PLAN COMMISSION MEETING

Monday, September 09, 2024 at 5:30 PM

- E.** Review of Site and Architectural Plan for Sauve’s Auto Service addition, located at 1421 Washington St, submitted by ACE Building Service (applicant) and Thomas Christensen (owner).

1609 - 16th Street

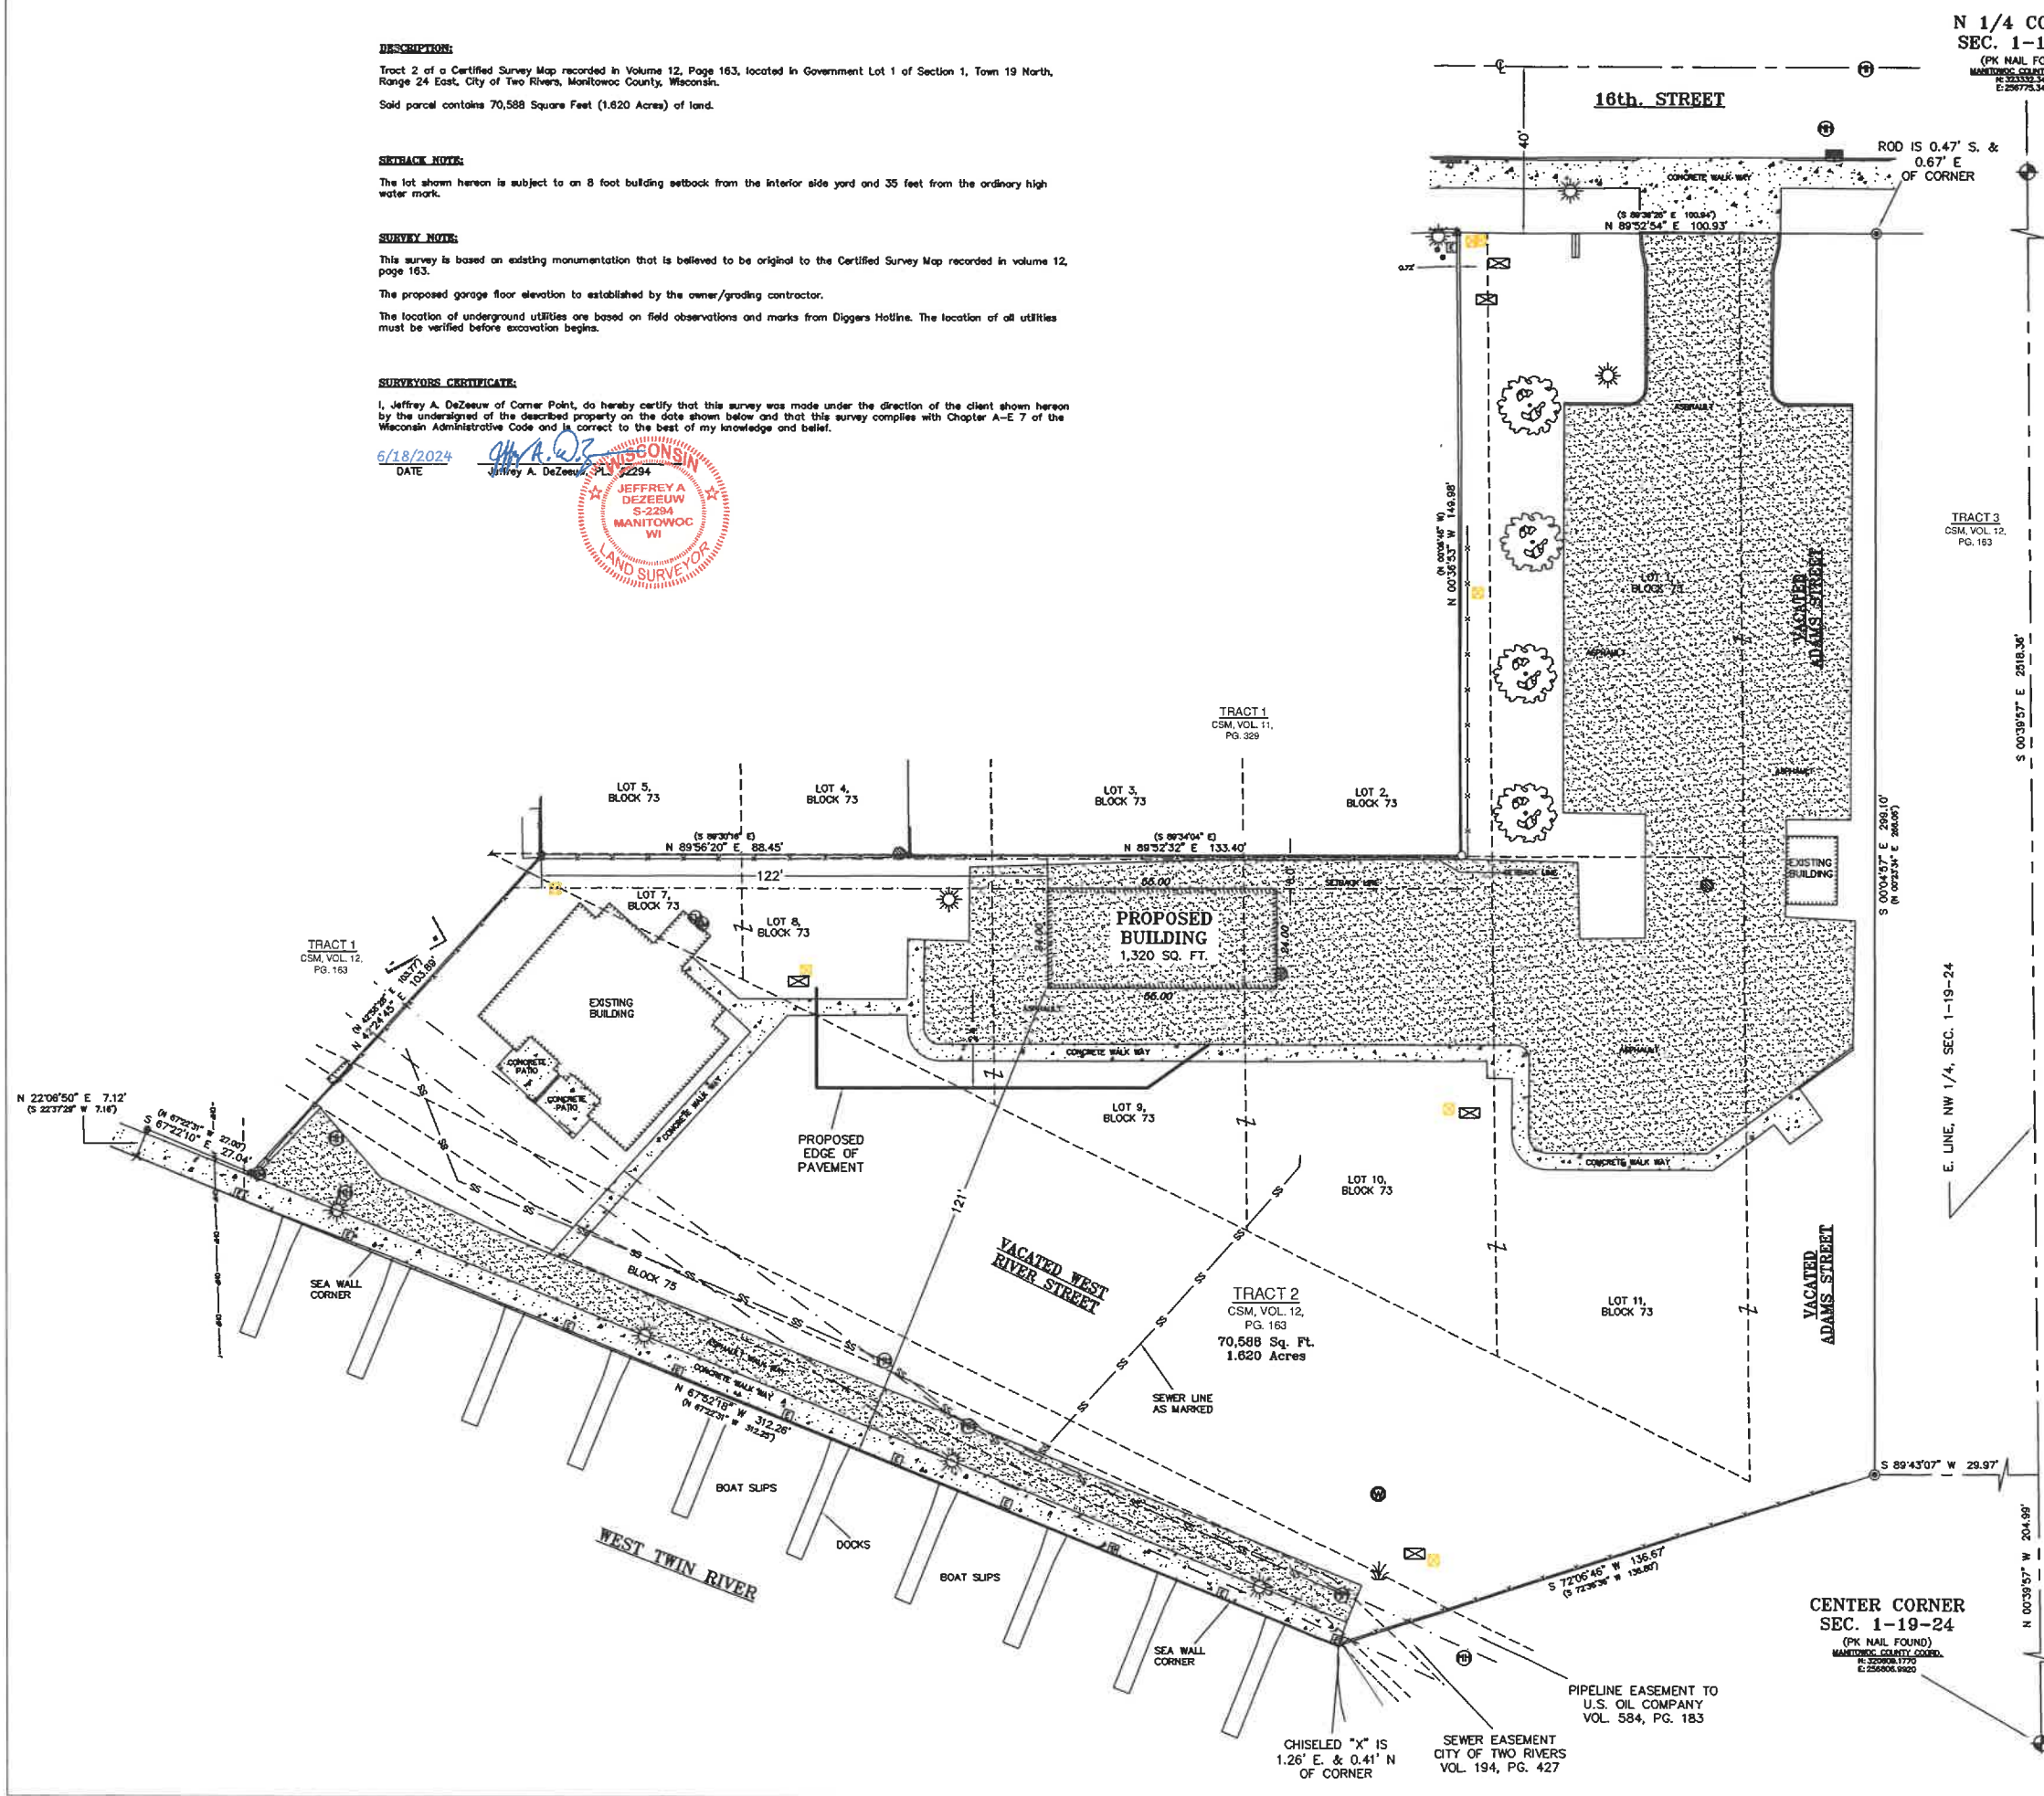
The owner of this property is requesting a change to the previously approved PUD, to construct a garage, closer to the dwelling unit. Staff has raised questions about the location of the garage, in relation to existing easements presently impacting the site. The current site plan does not include the easements.
